BID ADDENDUM #1

November 14, 2024

Montecito Fire Protection District Fire Station 92 – Gates and Carport ITB# 2024-005

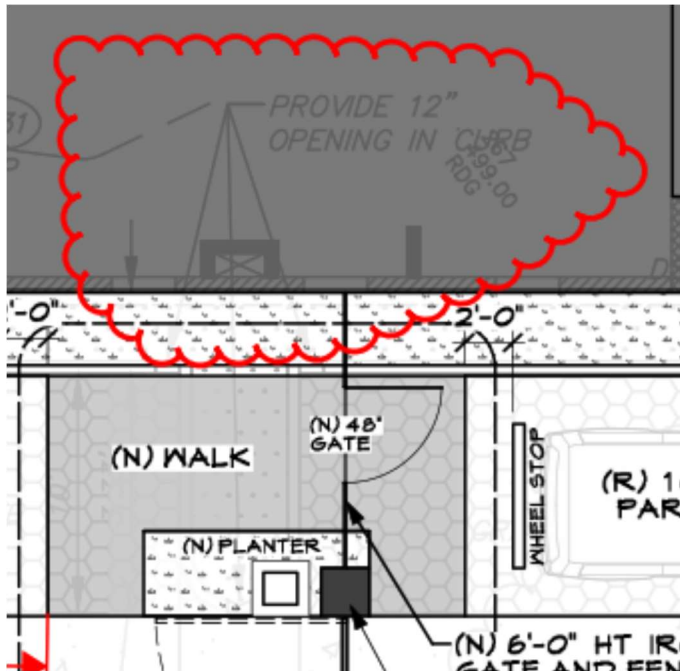
4. There is reference to solar accommodations for the future. What are the details as far as what you expect from the General Contractors?

Response: *The electrical plan includes preparatory work for future solar. In addition to what is shown on the plan, a 1-1/4" conduit from the carport structure post to the pull box at the building is to be installed for future panels on the roof.*

6. Sheet A1.0

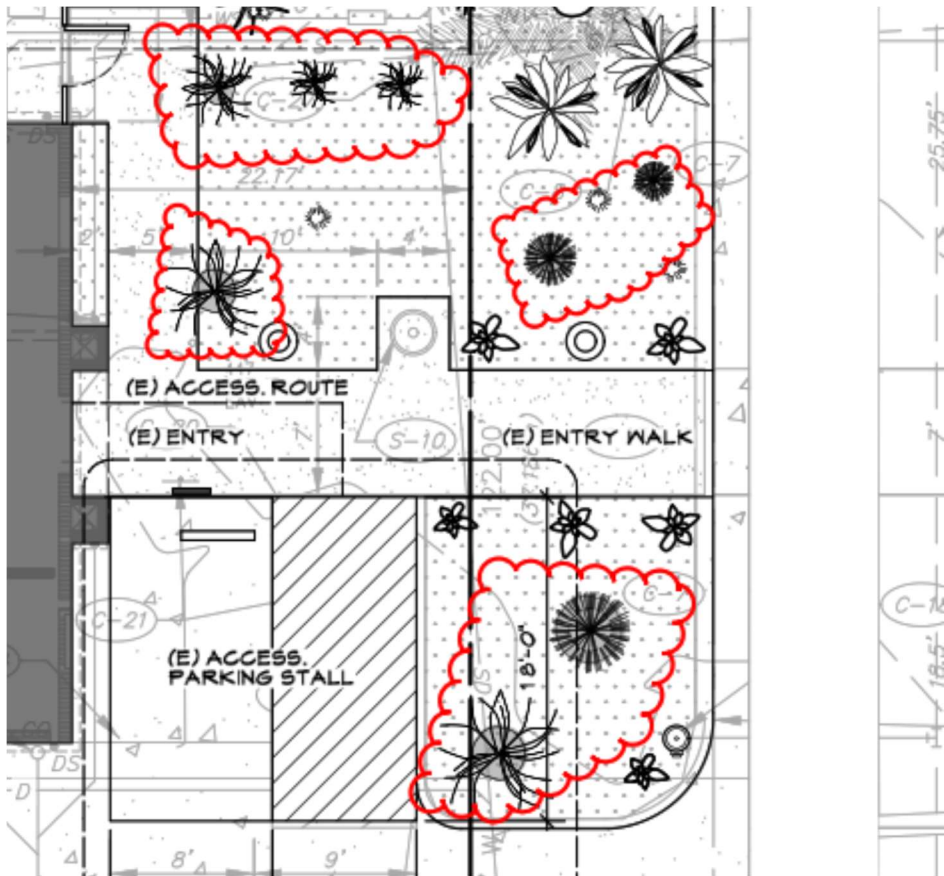
- a) Hidden in the shaded area in the building states "Provide 12" Opening in Curb". Please clarify what this is and provide details for the opening (see image below).

Response: *This is not a part of the scope of work. This is an archive from the existing original plans.*

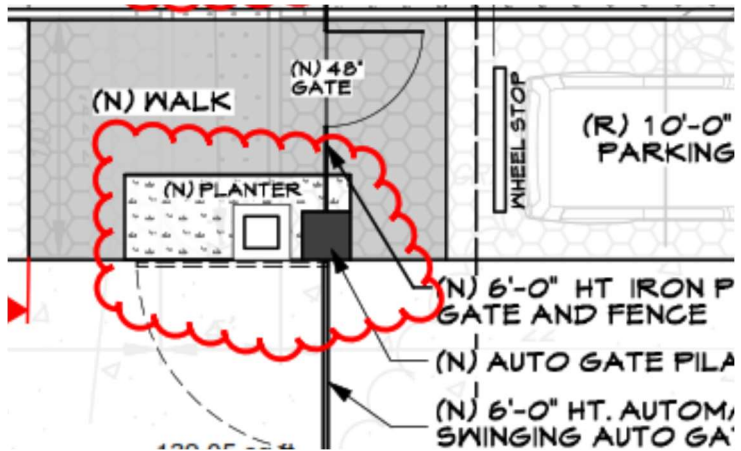
d) Site plan shows new planting to be installed at the Northwest corner of the site along Sycamore Canyon Road. Please confirm if new planting is to be installed in this location as planting already exists in this area (see image below).

Response: *Landscaping is not a part of this bid.*
